CIMARRON-NORTHWEST INDUSTRIAL FILING NO. 4

A REPLAT OF A PORTION OF LOT 1, BLOCK 2 CIMARRON-NORTHEAST INDUSTRIAL NORTHWEST
 LOCATED IN SECTION 6, TOWNSHIP 14 SOUTH, RANGE 65 WEST OF THE 6TH P.M.
 EL PASO COUNTY, COLORADO
 LOT 1 SCHLAUFMAN SUBDIVISION NO. 1., PLAT 12717

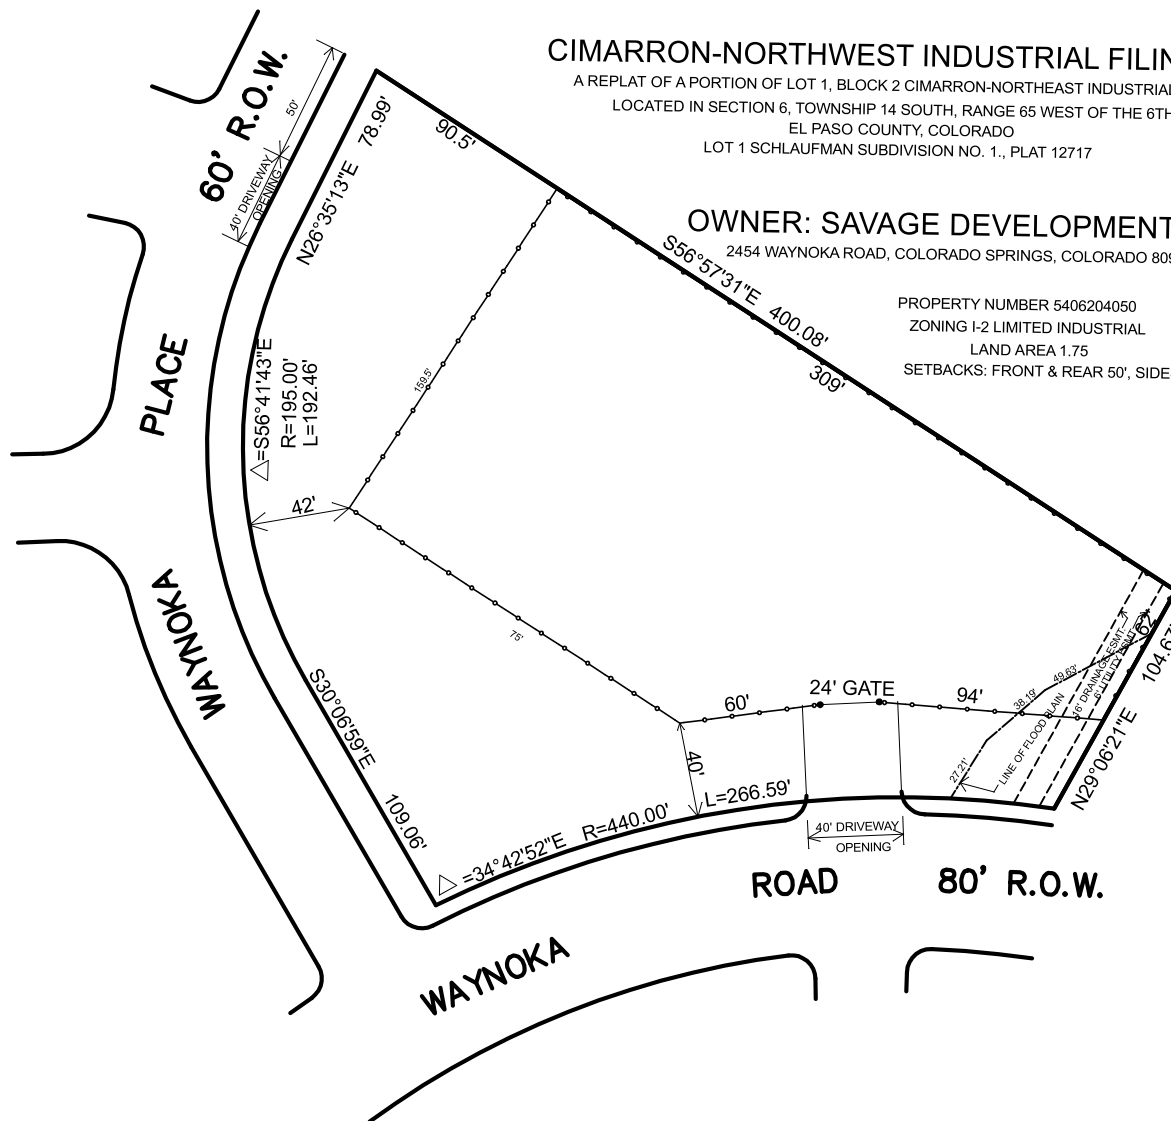
Landscaping is required. Roadway landscaping buffer area should be 10 feet deep with 1 tree per 30 feet of frontage. Internal landscaping should be 5% of land area, and 75% of that should be living landscaping. An alternative landscaping plan may be requested at the discretion of the PCD Director. Alternative landscaping requirements are located in section 6.2.2.A.4.

Landscaping is required. Roadway landscaping buffer area should be 10 feet deep with 1 tree per 30 feet of frontage. Internal landscaping should be 5% of land area, and 75% of that should be living landscaping. An alternative landscaping plan may be requested at the discretion of the PCD Director. Alternative landscaping requirements are located in section 6.2.2.A.4.

Landscaping is required. Roadway landscaping buffer area should be 10 feet deep with 1 tree per 30 feet of frontage. Internal landscaping should be 5% of land area, and 75% of that should be living landscaping. An alternative landscaping plan may be requested at the discretion of the PCD Director. Alternative landscaping requirements are located in section 6.2.2.A.4.
